Addendum No. 3

September 10, 2021

Project: San Fernando Regional Park Infiltration Project

**Attachment 4: Revisions to Diversion Pipe Plan and
Profile from Glenoaks Boulevard**

DWG NO. C-II
SHEET NO. 12 OF 46

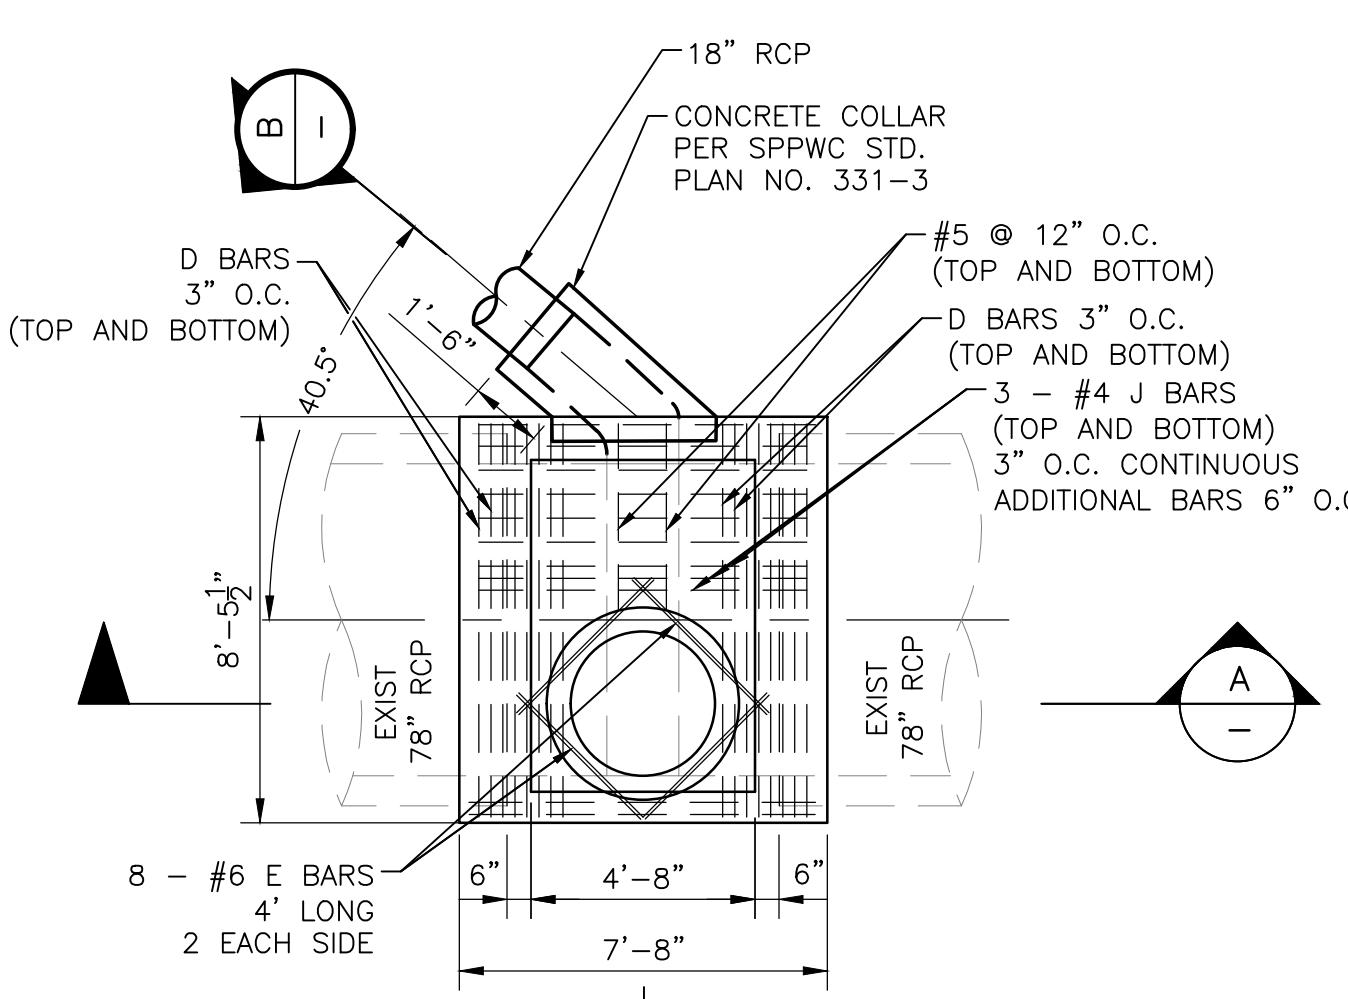
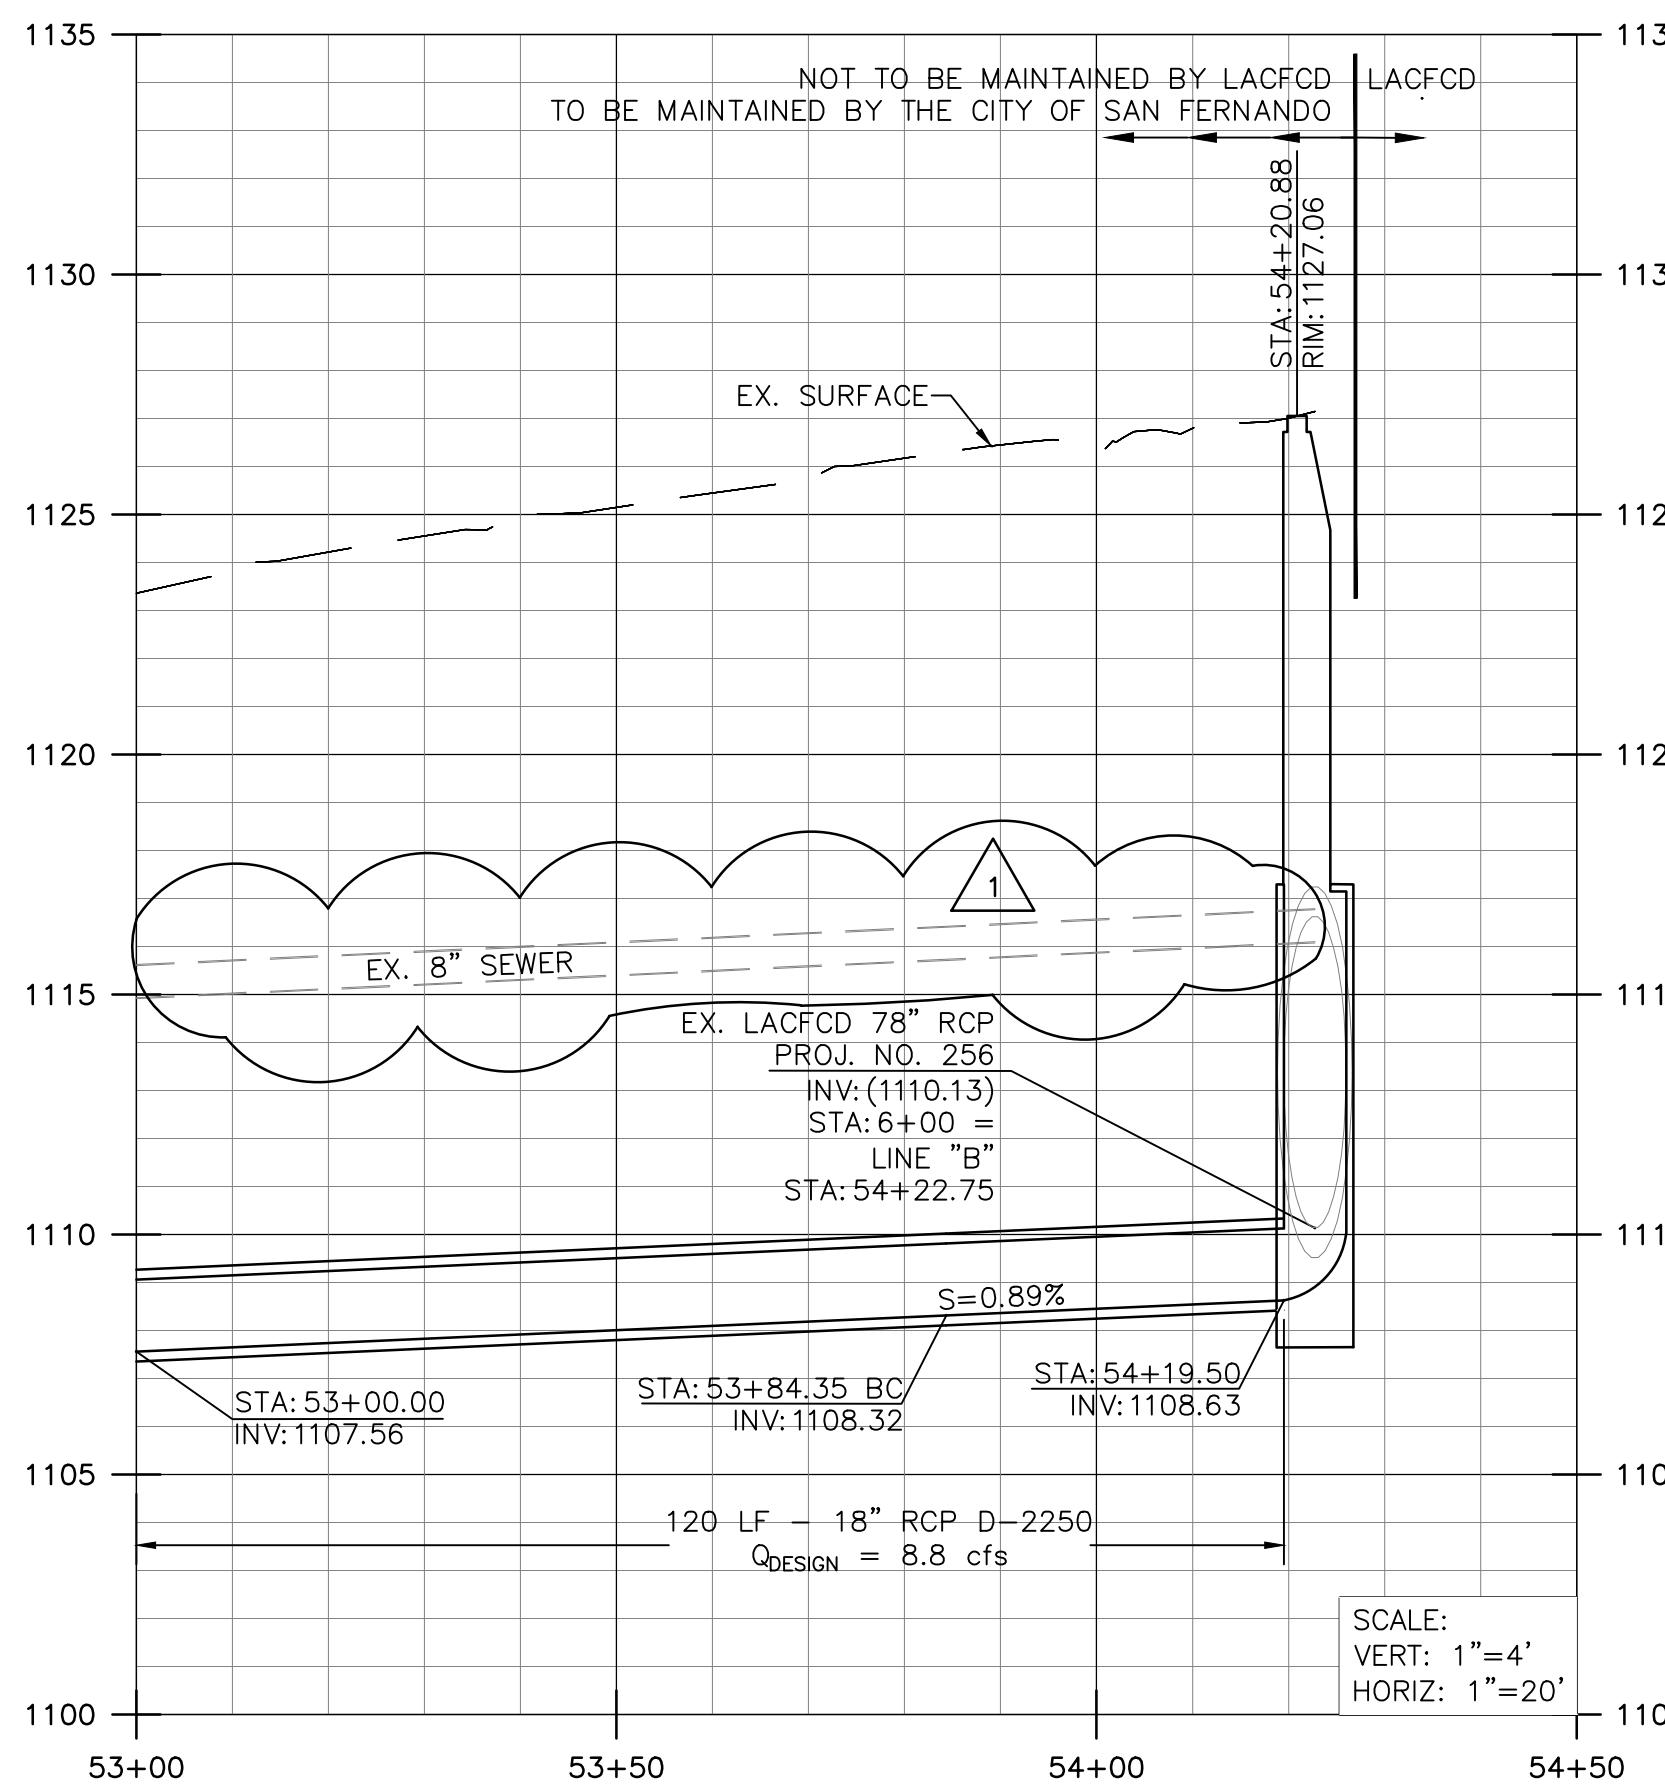
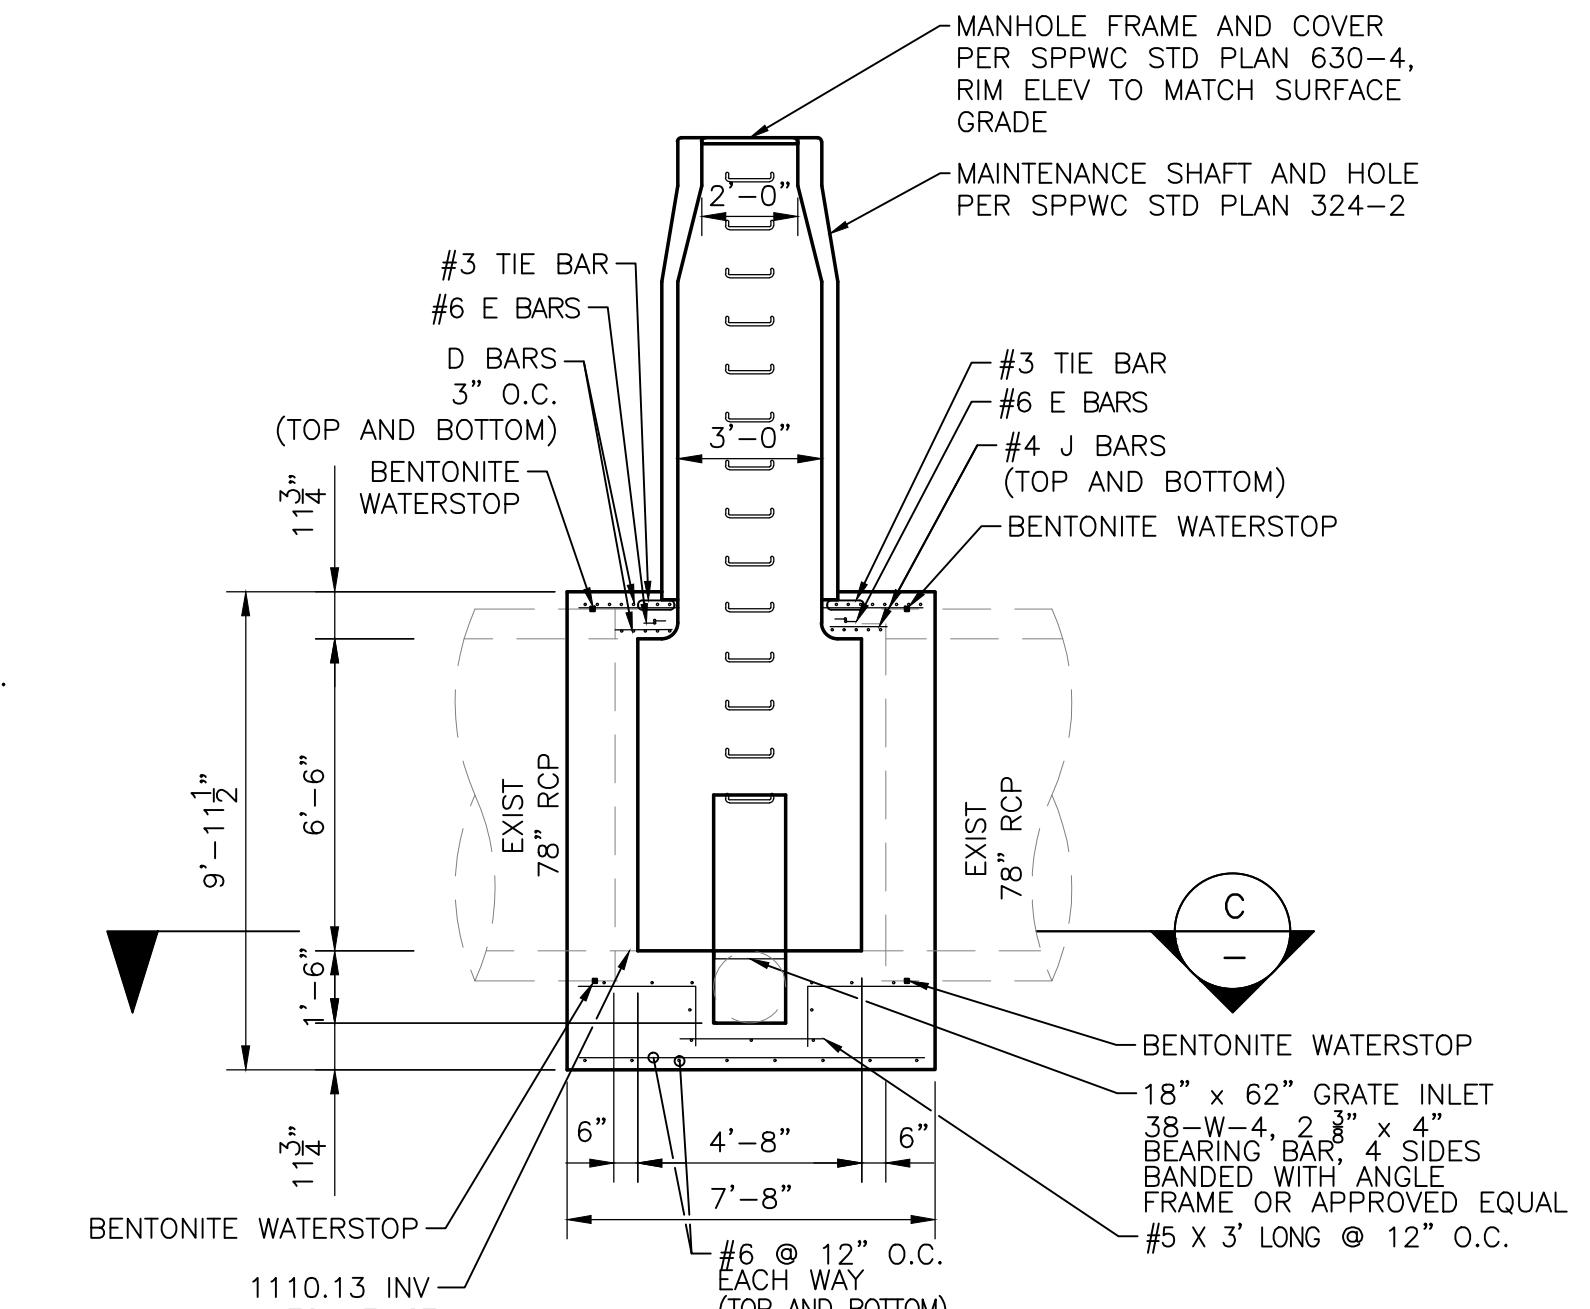
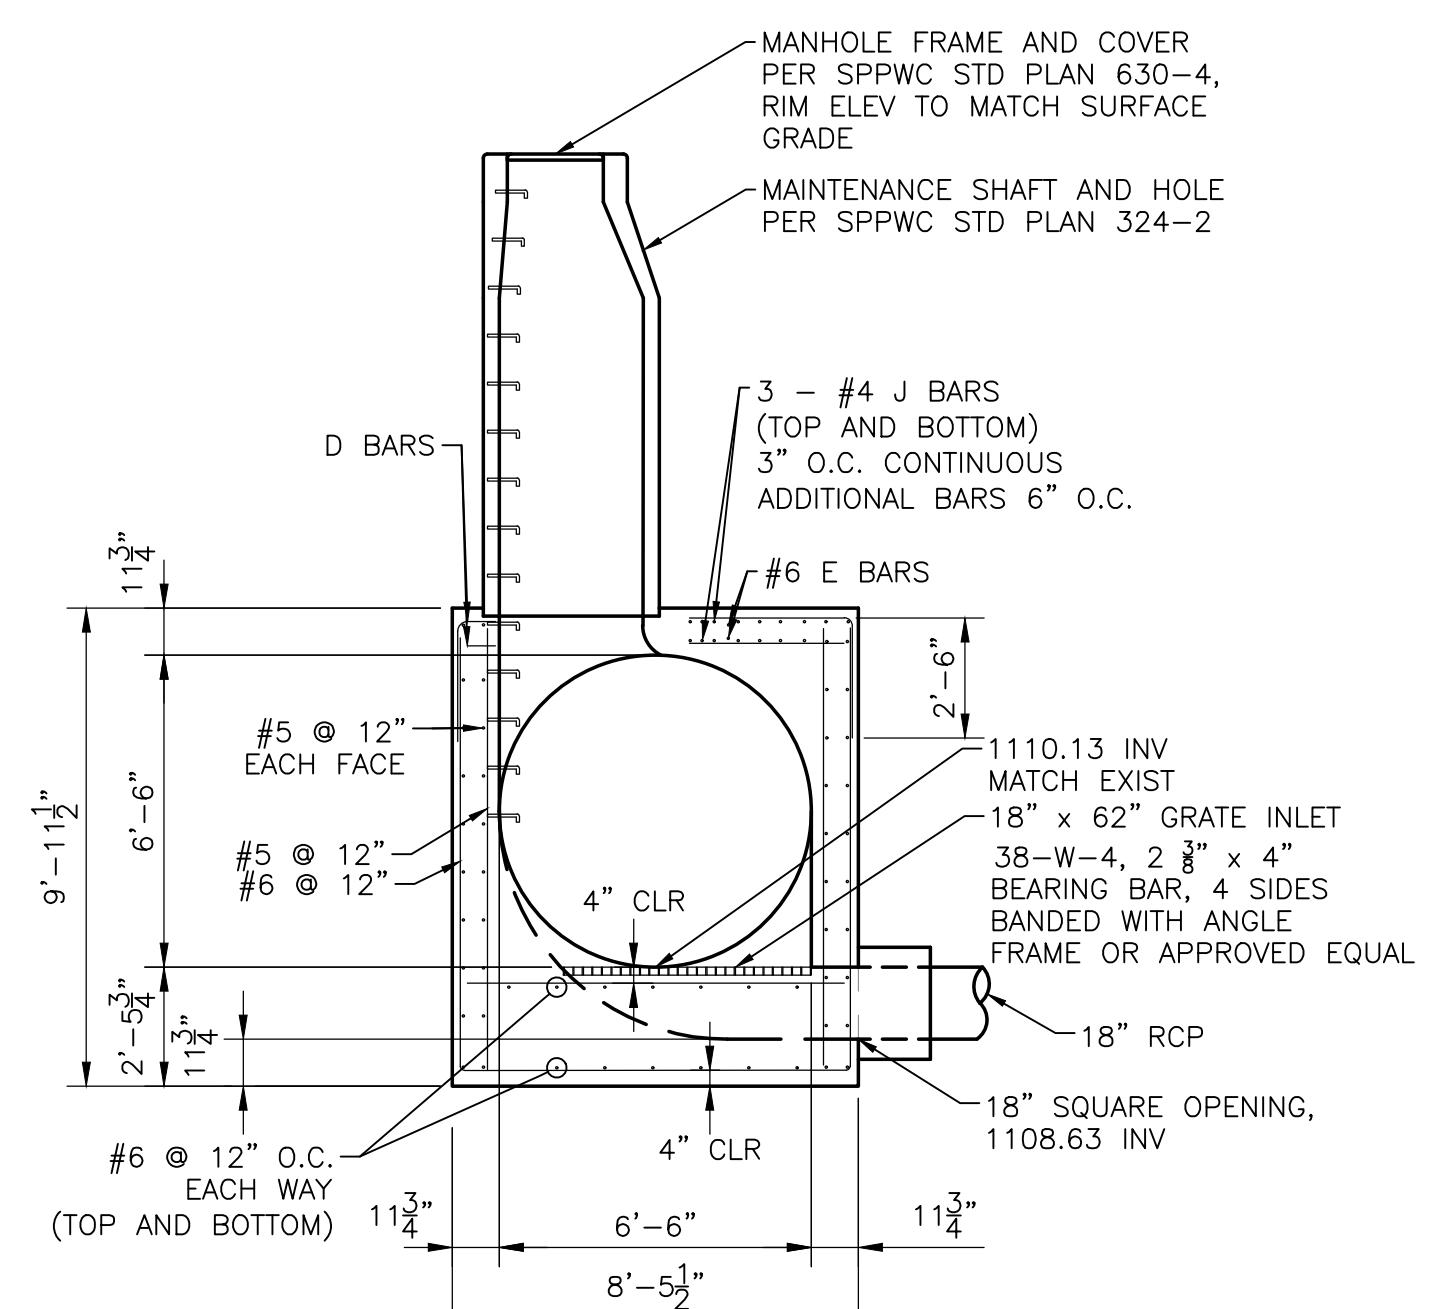
REV.	DATE	BY	DESCRIPTION	APP'D
1	9/7/21	TT	ADDED EX. SEWER LINE TO PROFILE; REVISED PIPE INVERT/SLOPE	
2	9/10/21	TT	ADDED HOUSE CONNECTION NOTE UNDER NOTES TO CONTRACTOR
